TEALING TO KINTORE UPGRADE PROJECT (TKUP) — TRL-120-1

WRITTEN RESPONSE TO PROCEDURE NOTICE DATED 7 JULY 2026

MATTER 7: MAJOR ACCIDENT HAZARD GAS PIPELINES

NOTKUP RESPONSE TO THE APPLICANT'S SUBMISSION DATED 24 JULY 2026

National Gas Transmission – High Risk Response Letter

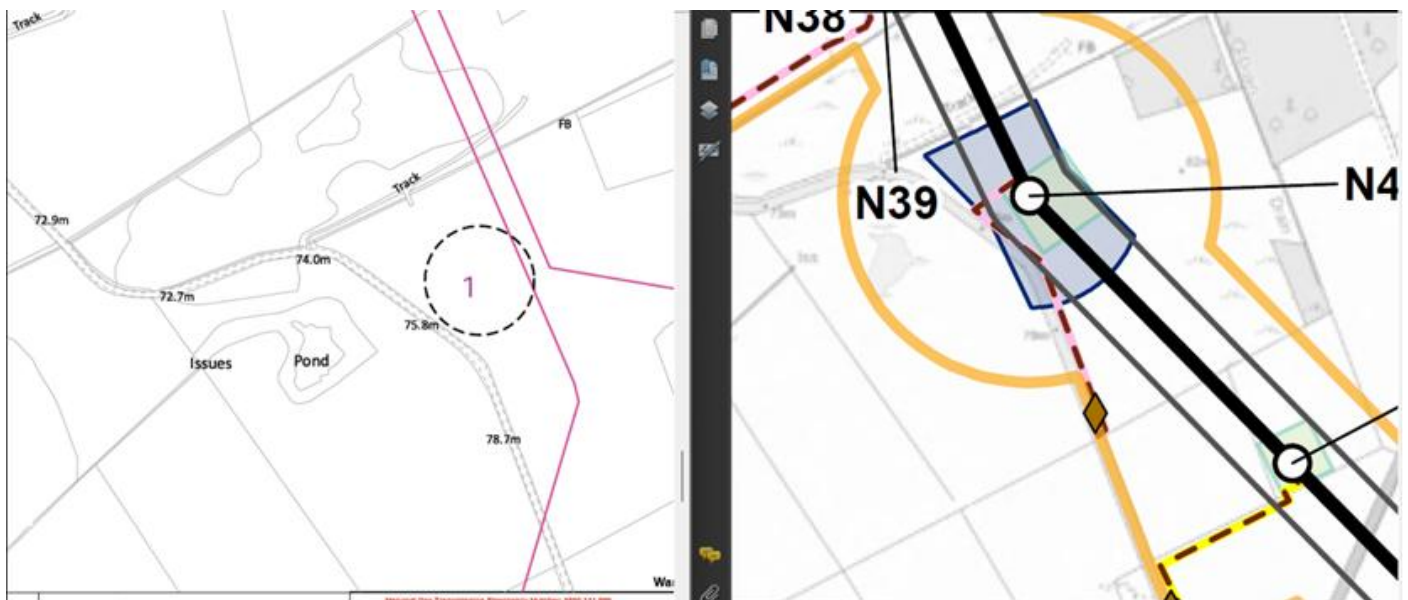
An assessment has been carried out with respect to National Gas Transmission plc's apparatus and the proposed work location. Based on the location entered into the system for assessment the area has been found to be within the High Risk zone from National Gas Transmission plc's apparatus and you **MUST NOT PROCEED** without further assessment from Asset Protection.

NGT map (left) showing N40 pylon location and two, purple, HP Feeder gas pipelines alongside the SSN LOD map (right) Note the track and the rectangular wooded plot top right.

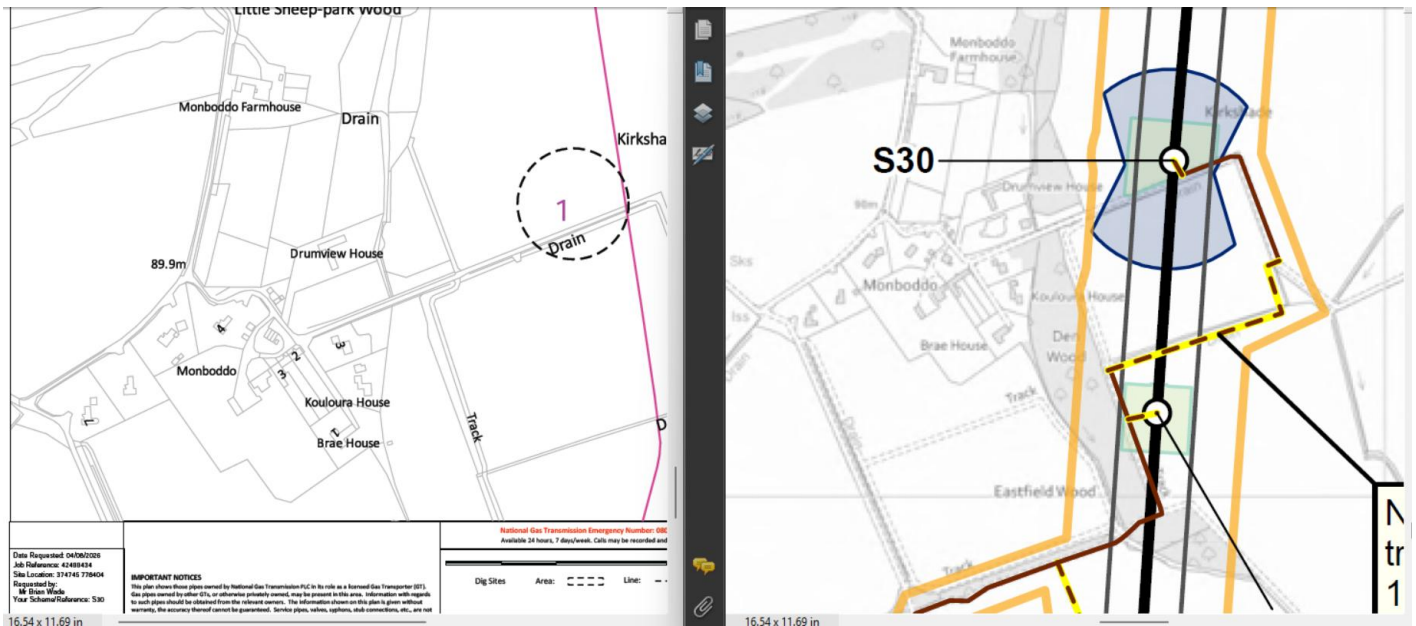
55. The Applicants state: *“All tower locations on the Proposed Development are outwith the pipeline Easement Zones and Build Proximity Distances which reduces the interaction during the construction phase of the Proposed Development.”* However a Linesearch Before You Dig enquiry for pylon N40 returned the following reply from NGT.
